Product Change Notification / GBNG-02EIPE100

CCB 6067 Final Notice: Qualification of STAR as an additional final test site for MICRF221AYQS and MICRF221AYQS-TR catalog part numbers (CPN) available in 16L QSOP (3.90mm) package.

PCN #: GBNG-02EIPE100

Pre and Post Change – Tape and Reel

Pre and Post Change – Plastic Reel

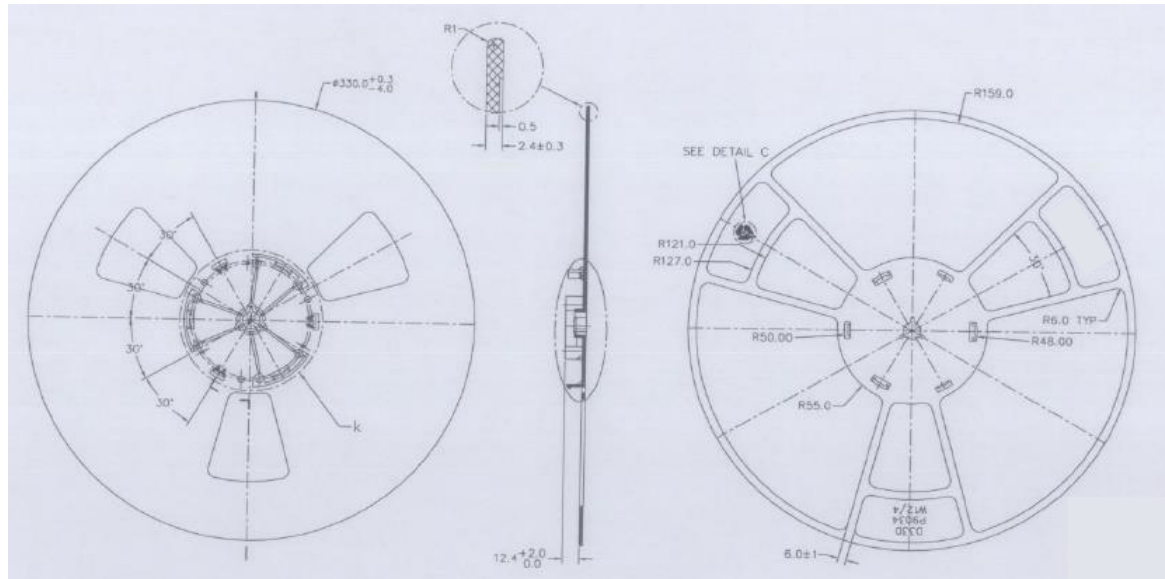
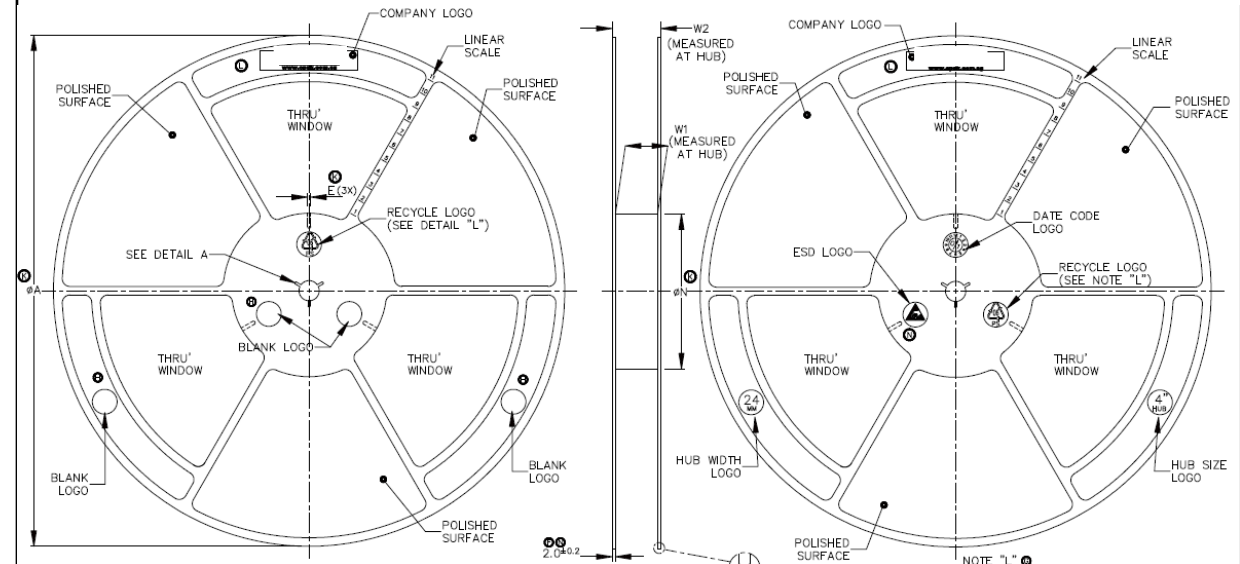
No dimension change.

Pre and Post Change – Carrier Tape

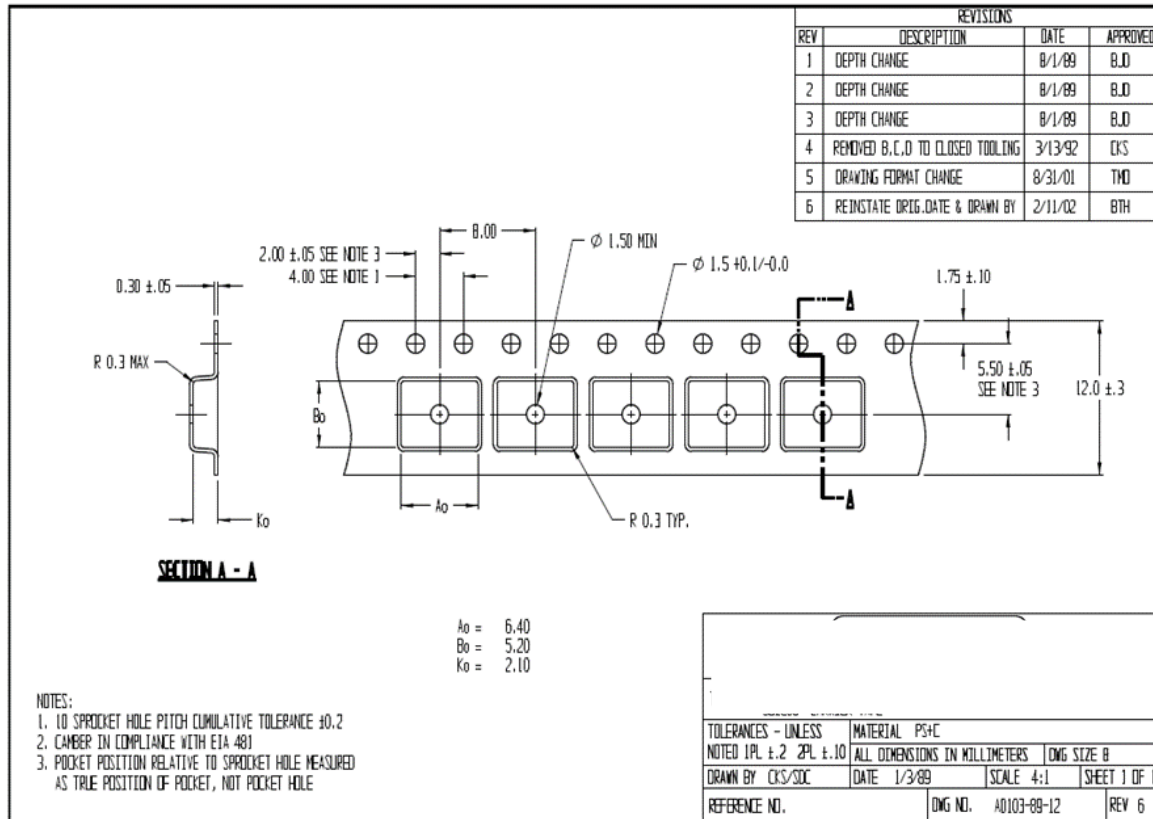
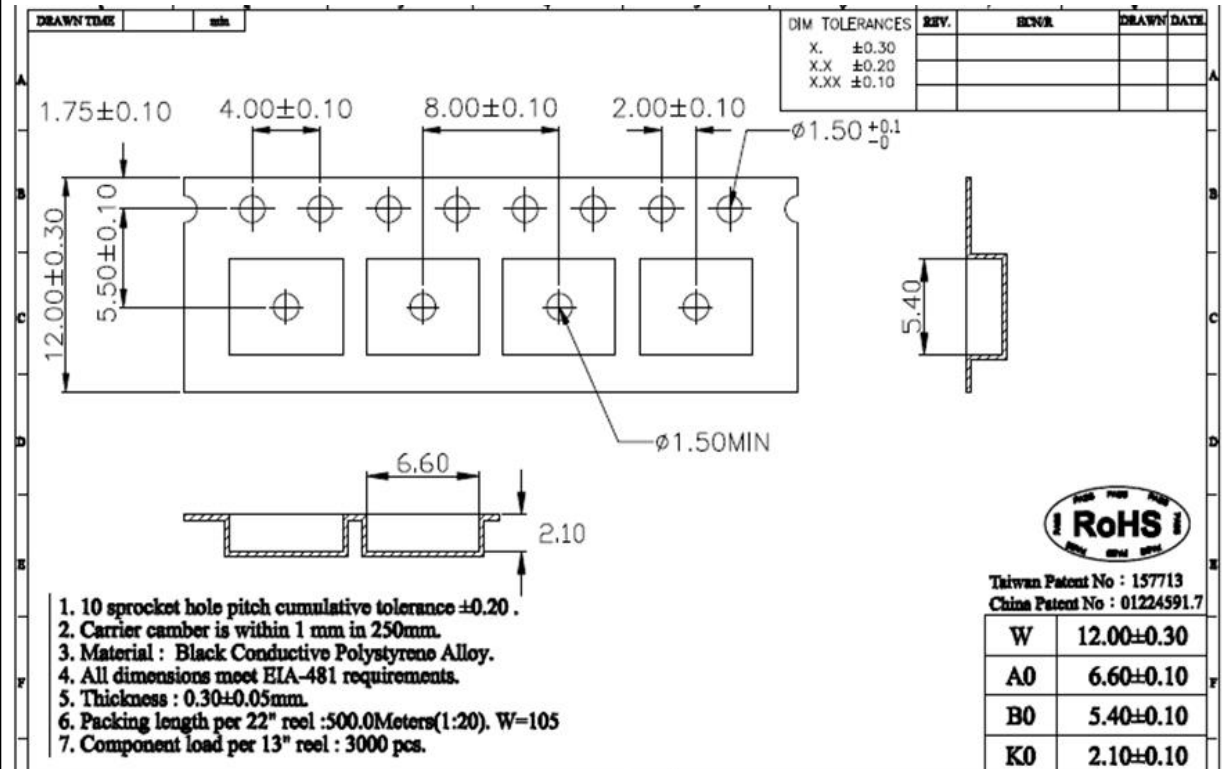
Plant	W (mm.) ± 0.3 or Specific	P (mm.) ± 0.1 or Specific	A ₀ ± 0.1 or Specific	B ₀ ± 0.1 or Specific	K ₀ ± 0.1 or Specific
UNIS	12	8	6.40	5.20	2.10
STAR	12	8	6.60	5.40	2.10

Pre and Post Change – Cover Tape

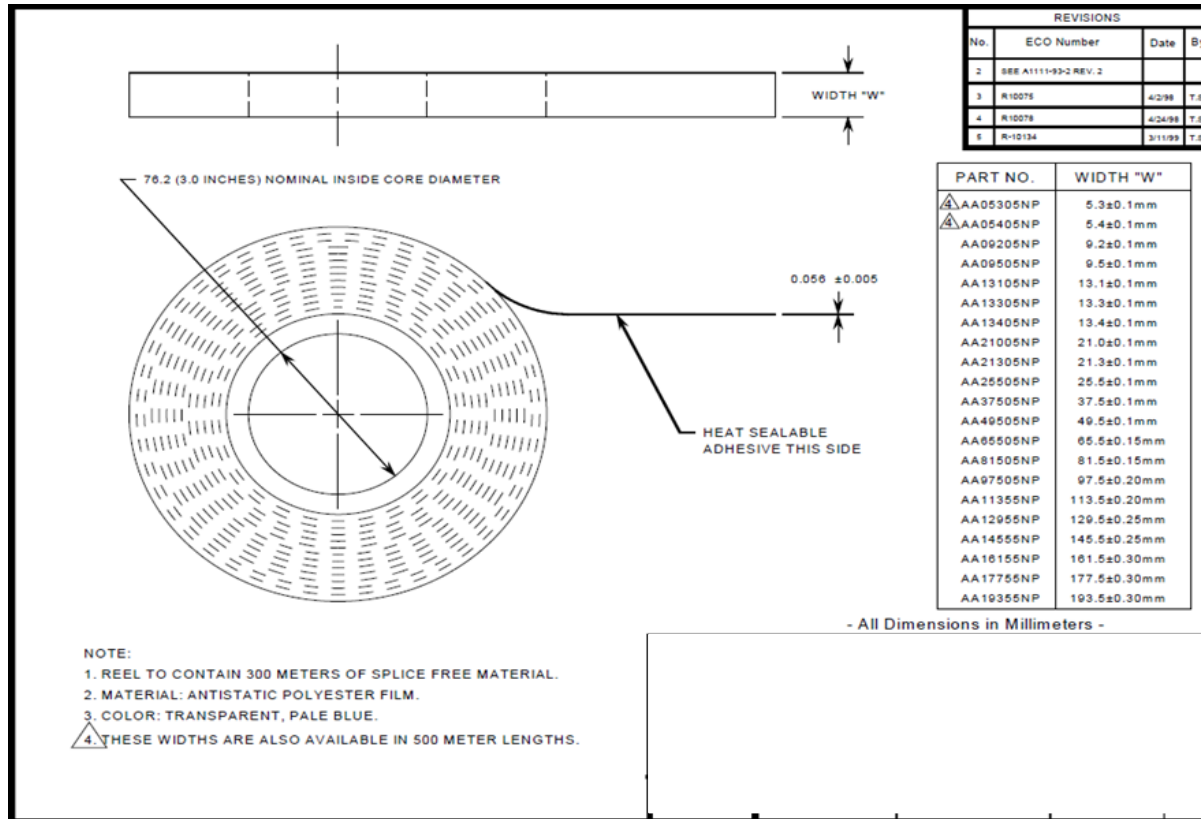
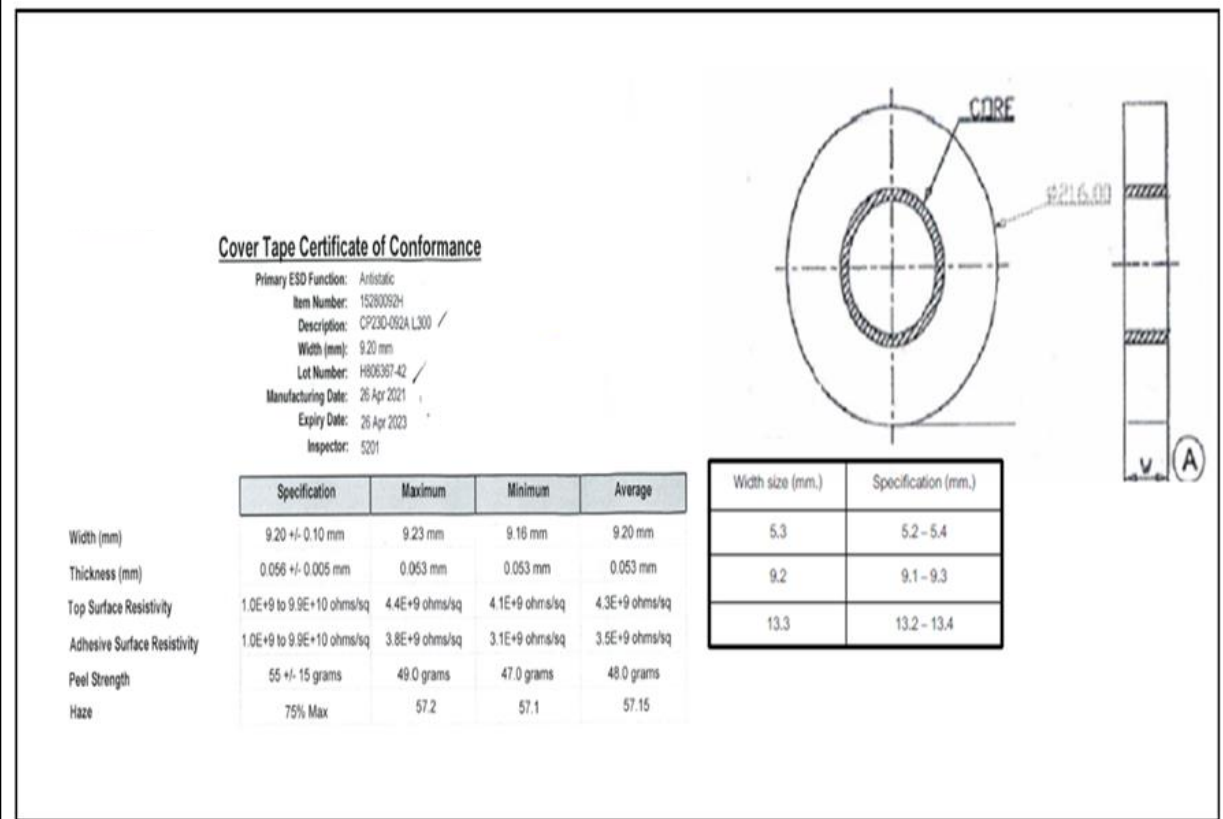
Plant	Carrier Tape Width	Cover Tape Width	Thickness	Color	Sealing mythology
UNIS	16mm	13.3 +/-0.1mm	0.056+/-0.005	Clear	Heat sealing
STAR	16mm	13.3 +/-0.2mm	0.050+/-0.005	Clear	Heat sealing
